ROSEVILLE
REQUEST FOR CITY COUNCIL ACTION

Item Description: Request by JAVA Properties for approval of a Preliminary Plat at 2700 Cleveland Avenue

REQUEST FOR PLANNING COMMISSION ACTION

Item Description: Request by JAVA Properties for approval of a **Preliminary Plat** at 2700 Cleveland Avenue (PF15-002).

SITE PLAN

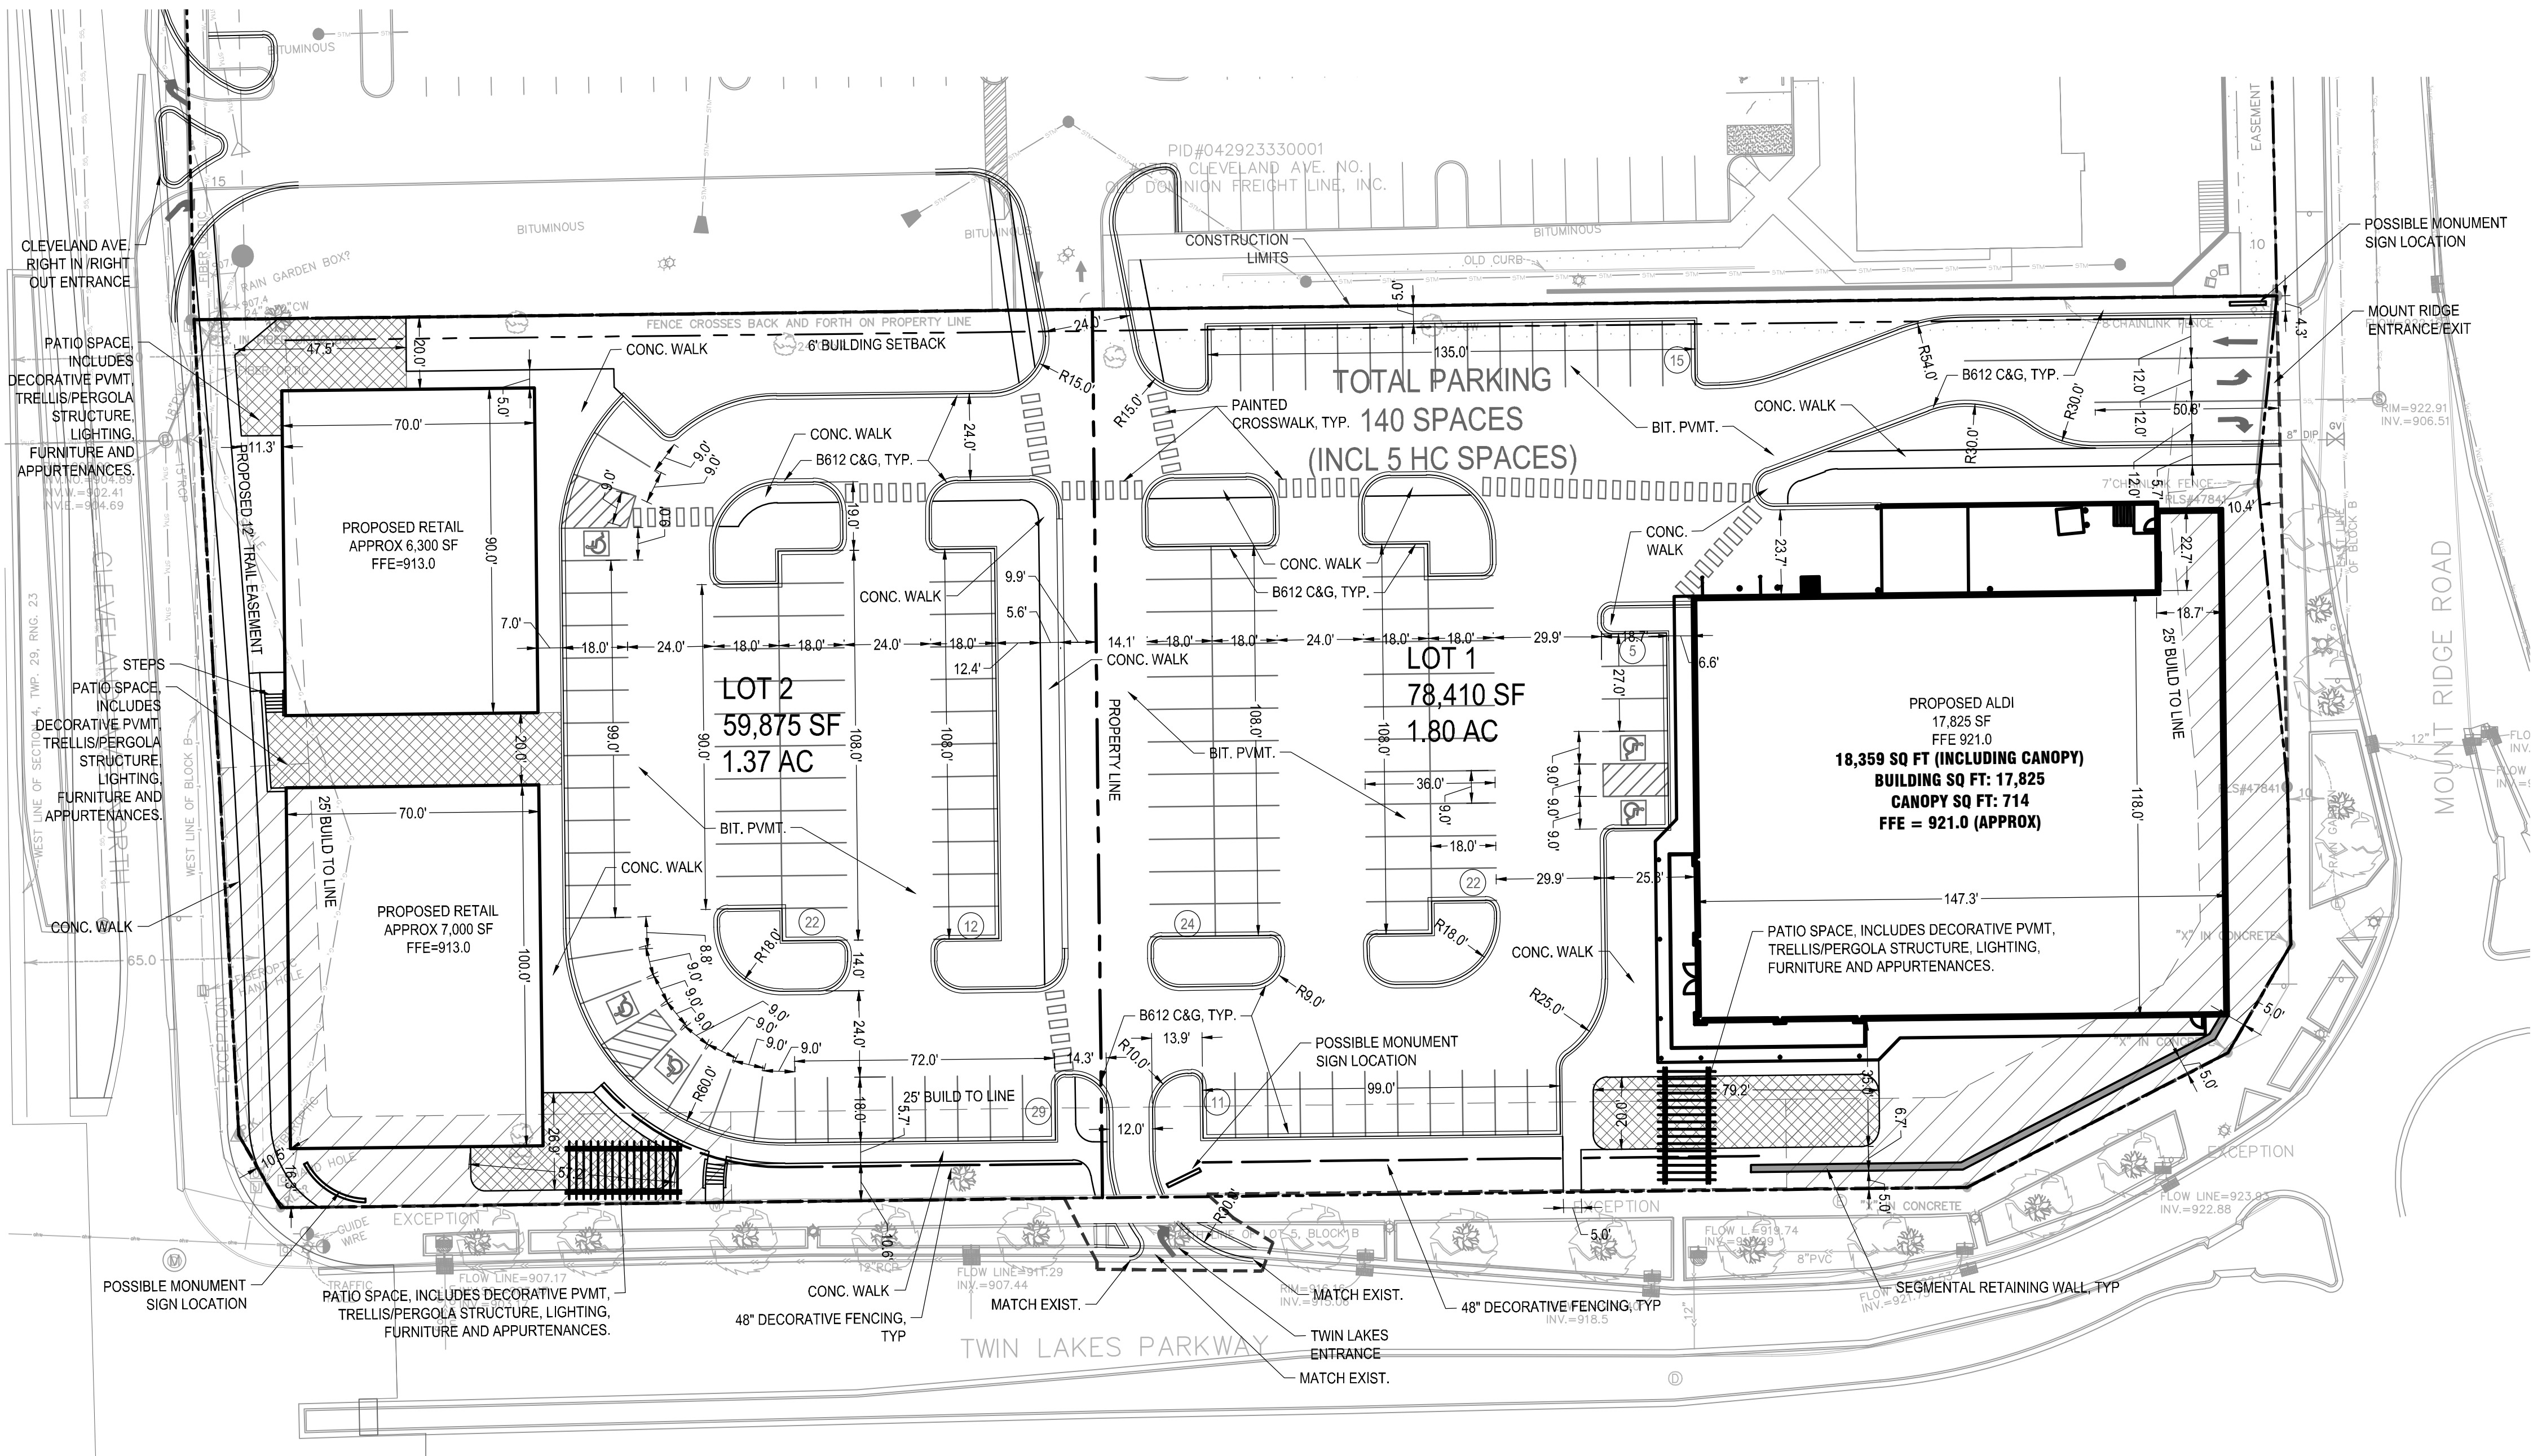
The proposed development is requesting access along Twin Lakes Parkway, Mount Ridge Road (shared), and Cleveland Avenue (shared). The proposed access points and the impact of the overall development on the surrounding transportation system will be evaluated by a traffic study commissioned by the City of Roseville. The developer is required to pay their share (\$2554) of this study with the development to the north sharing the cost.

The DRC views the JAVA development site and the proposed hotel site to the north as a unified development and, therefore, will be requiring access and shared parking agreements between the two sites. The DRC has recommended that both development teams work together to address grade issues while minimizing the use of retaining walls, if possible. The DRC also strongly encourages the development teams to coordinate storm water mitigation requirements. This coordination will minimize infrastructure costs, improve customer experience, and reduce demands on adjacent streets.

Drainage and utility easements will be required along the perimeter of the developed lot with a width to be determined by the City Engineer. Also, sufficient right-of-way or easement will be required, as well as the construction of a pathway by the developer/applicant along the east side of Cleveland Avenue from Twin Lakes Parkway to the north limits of the development.

- a. The developer/applicant is responsible for coordinating grading, drainage, and storm water management plans with the adjacent (north) proposed development site to potentially eliminate unnecessary grade changes, portions of a retaining wall, and a steeper-than-preferred joint access grade;

- 91 h. The developer shall dedicate and maintain access easements across its lot in a form
92 acceptable to the City Attorney to ensure permanent access to Mount Ridge Road and
93 from Twin Lakes Parkway for the adjacent parcel; and
